CITY OF ONTARIO DEVELOPMENT ADVISORY BOARD

AGENDA

October 17, 2016

- B. ENVIRONMENTAL ASSESSMENT AND DEVELOPMENT PLAN REVIEW FOR FILE NO. PDEV16-029:** A Development Plan (File No. PDEV16-029) to construct 226 conventional single-family homes on 49.95 acres of land located within the RD-5,500 (Neighborhood 1) and RD-5,000 (Neighborhood 3) of the Countryside Specific Plan, located at the southwest corner of Riverside Drive and Colonial Avenue. The impacts to this project were previously analyzed with the Countryside Specific Plan EIR (SCH# 2004071001) that was adopted by the City Council on April 18, 2006 and was prepared pursuant to the requirements of California Environmental Quality Act. All adopted mitigation measures of the EIR shall be a condition of approval for the project and are incorporated herein by reference. The proposed project is located within the Airport Influence Area of Ontario International Airport (ONT), and was evaluated and found to be consistent with the policies and criteria of the ONT Airport Land Use Compatibility Plan (ALUCP). (APNs: 0218-111-52 and 0218-111-57); **submitted by DR Horton. Planning Commission action is required.**

Exhibit D: Conceptual Front Yard Typical Landscape Plan - Express

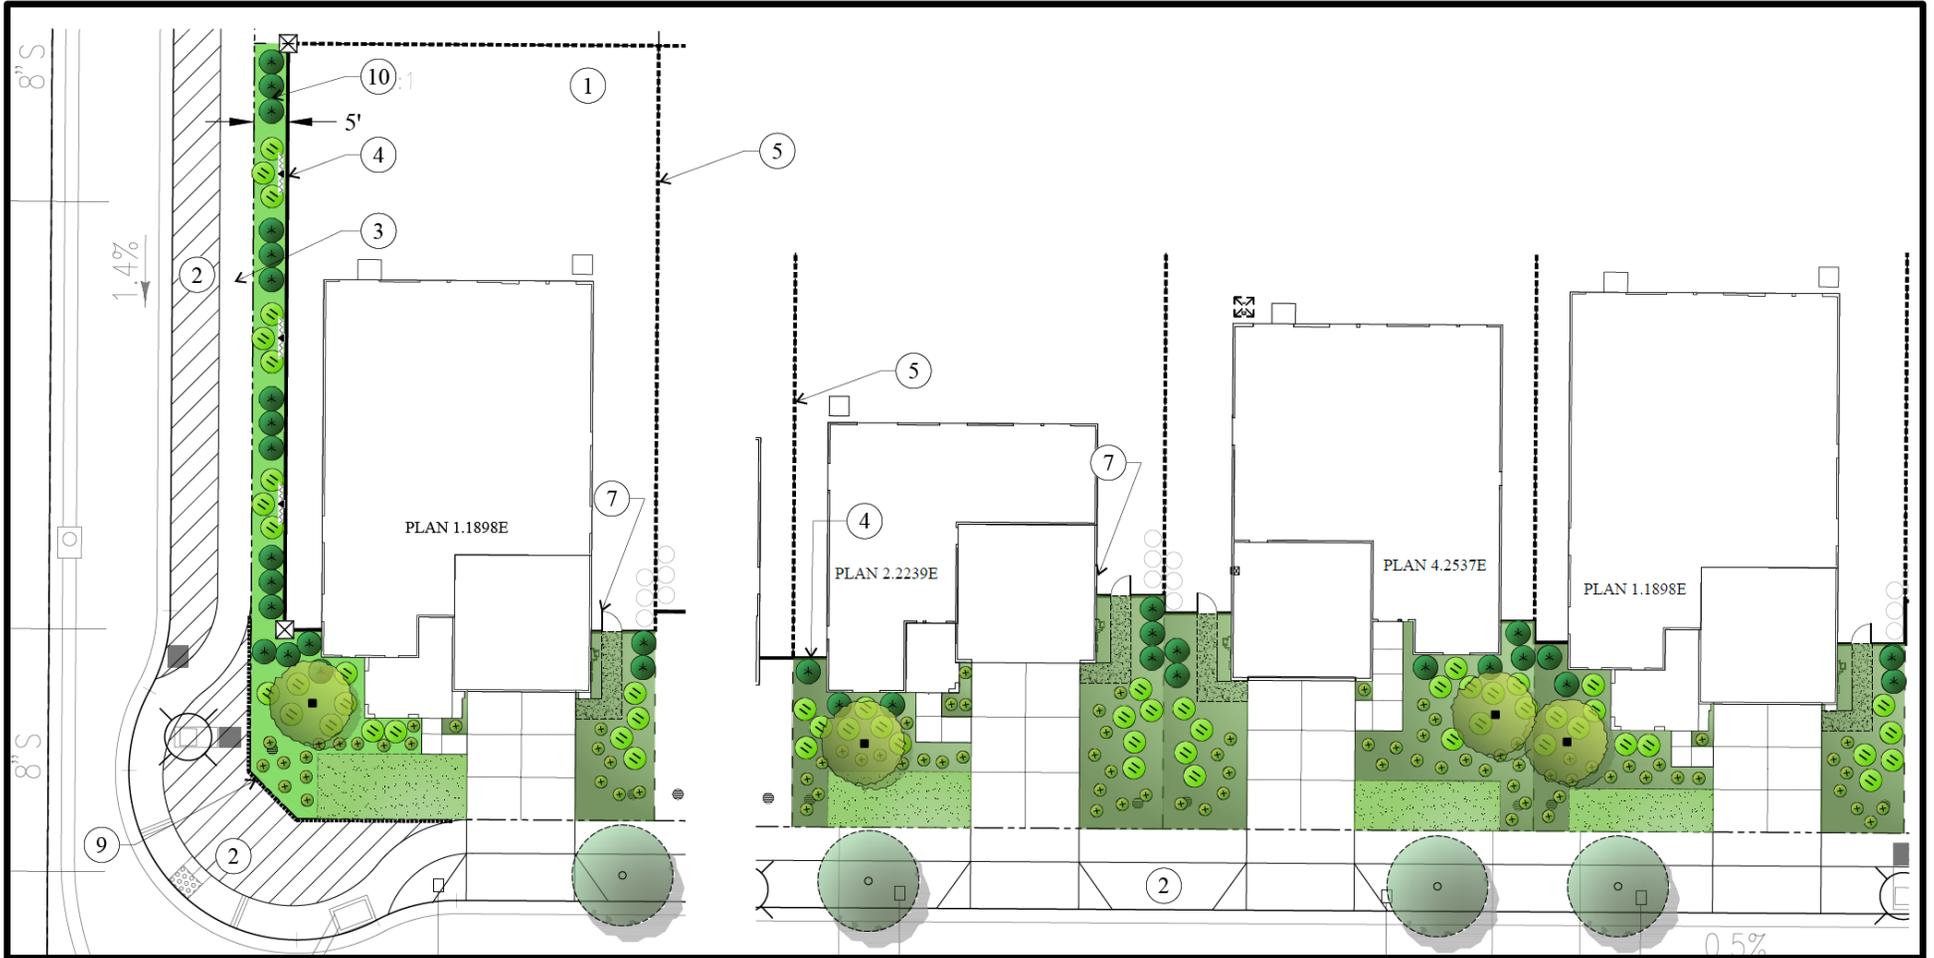
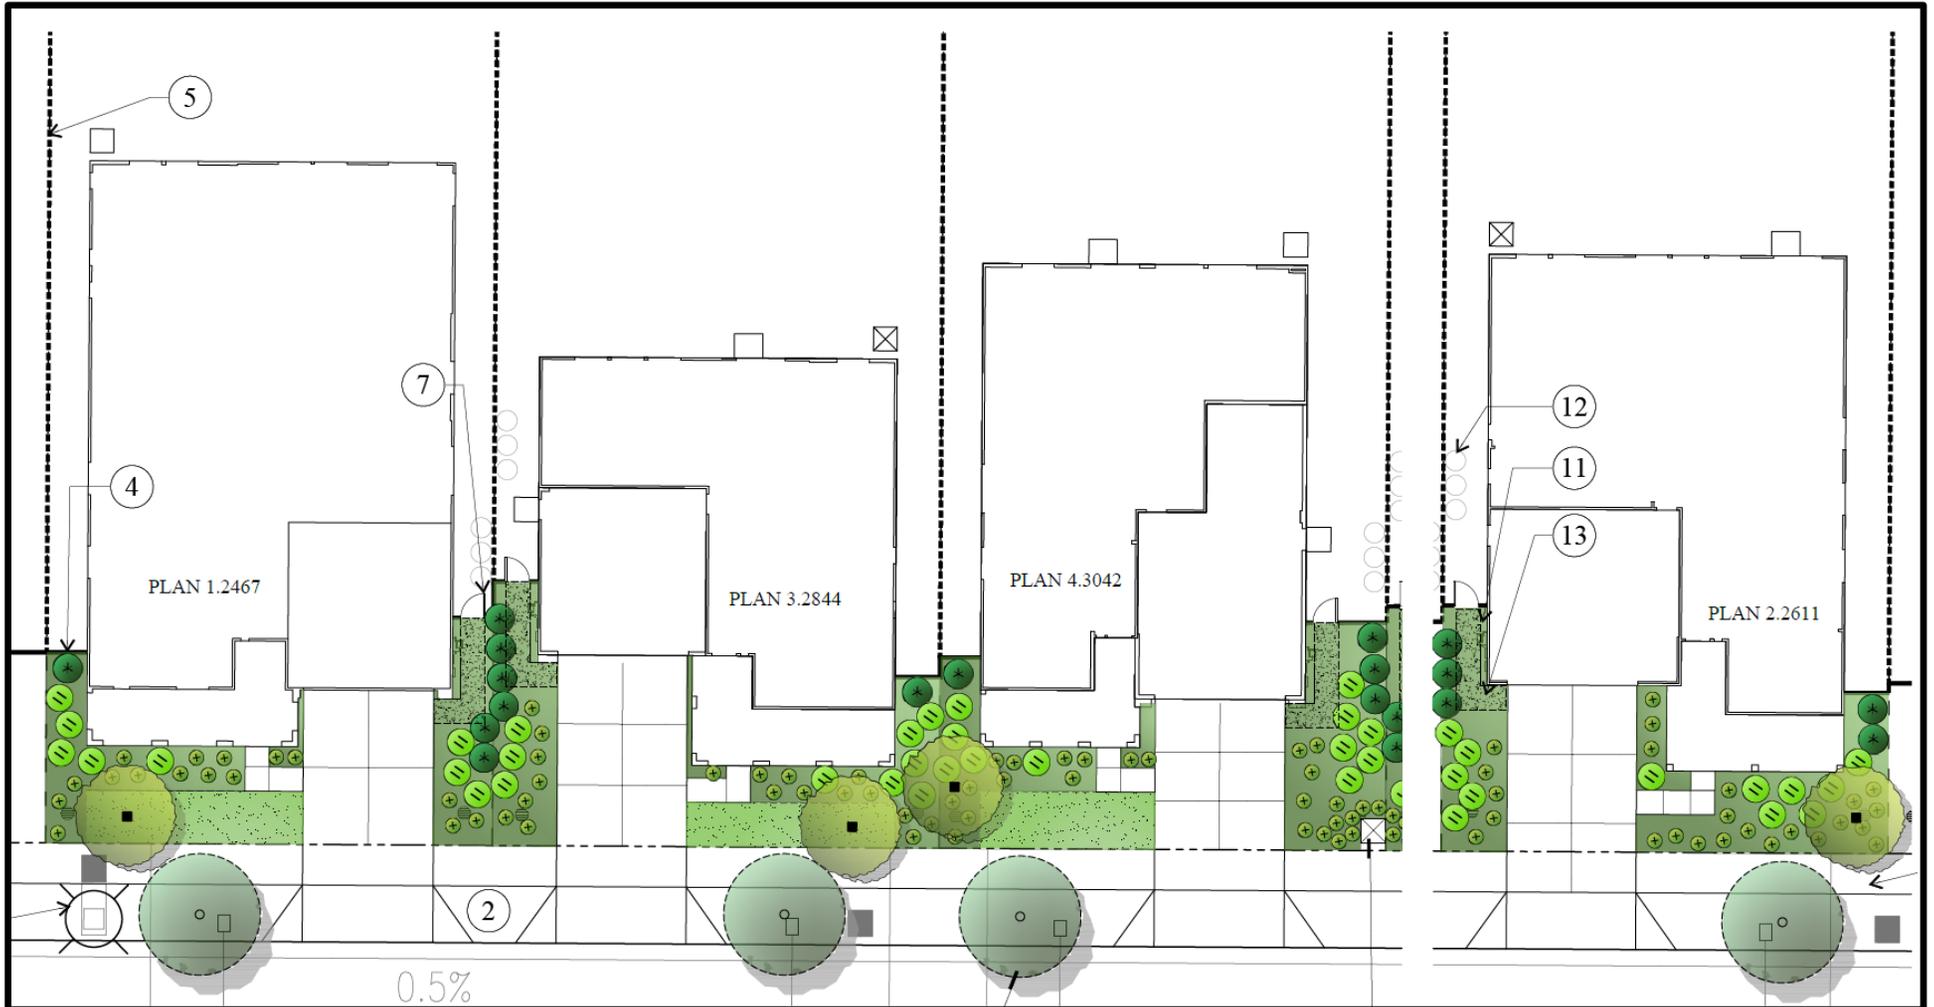
7. Correct scale (not 1"=10' when printed 24 x36), size of symbols in legend and all text shall be min 1/8" size capital letters.
8. Show plant material spaced equal to the mature width. Add plants – plan is too sparse. Add on-center spacing to legend. If proposing groundcovers, use in a large area and not mixed between the shrubs.

10. Provide a typical landscape plant palette for shaded site such as north or east facing lots.
11. Replace short lived or difficult to maintain plants such as Festuca, Bougainvillea, Lantana.

12. Show large shrubs or small tree (Heteromeles) in a single location. Where a narrow hedge is shown consider Ligustrum, Nandina, or Prunus caroliniana instead.

13. Show two trees for each front yard lot. Alternate deciduous with evergreen, large with small trees.
14. Provide an overall site plan showing all trees.

15. Show lawns no less than 10' wide. Consider using lawns only in the larger front yards where the garage is set back and groundcover only in the smaller front yards.
